SUBJECT: Design Staff Recommendation Regarding The Selection
Of Development Teams For Chinatown Parcel R-3/R-3A

DESIGN EVALUATION OF DEVELOPMENT PROPOSALS

CHINATOWN PARCEL R-3/R-3A

BOSTON REDEVELOPMENT AUTHORITY

SHADOW STUDY - AUTUMN & SPRING

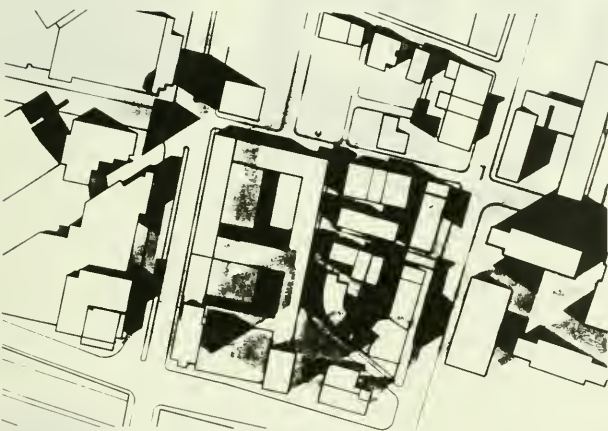
Shadow impact on the adjacent neighborhood is not extensive. The elderly tower, however, will cast a shadow on the proposed Pine Stett in-fill townhouses and the back of the church during late afternoon in autumn and spring.

The proposed courtyards enjoy a balance of sunlight and shade through most of the year. Most of the upper courtyard, however, will be in shadow during late afternoon in autumn and spring.

SHADOW STUDIES MARCH/SEPTEMBER 21 9a.m.
CHINATOWN Parcel R-3/R-3A

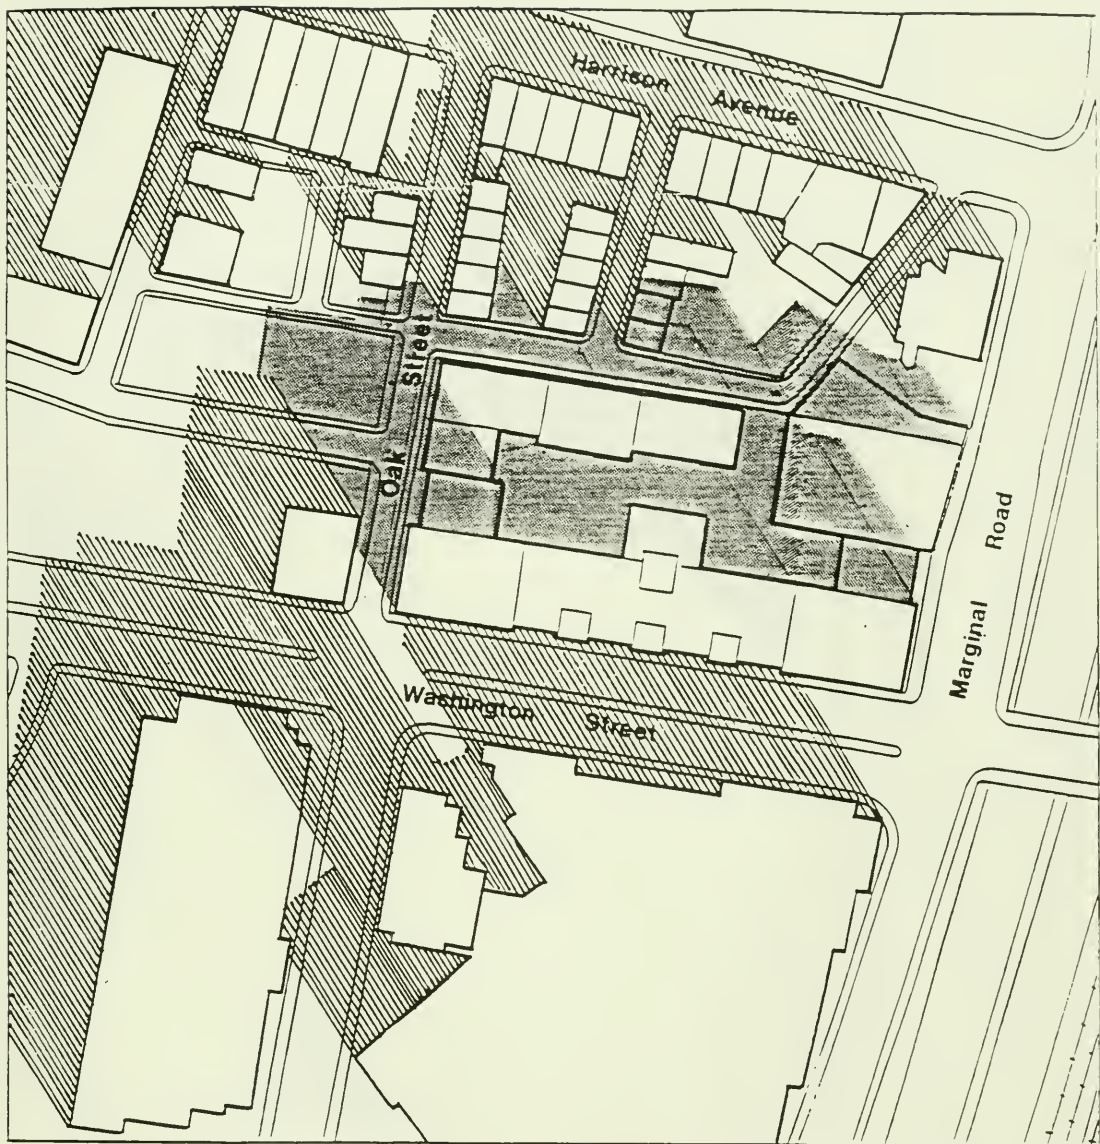
- o Shadow impact on the adjacent neighborhood:
The Washington Street-Oak Street tower will cast shadows on the future housing site across Oak Street during afternoons throughout the year (except summer.) During autumn and spring mornings, this tower will also cast extensive shadows on the vest pocket park in front of the Quincy Tower entry.

- o Shadow impact on proposed public open space.
The proposed courtyard will be entirely in shadow throughout the year except during summer mornings.
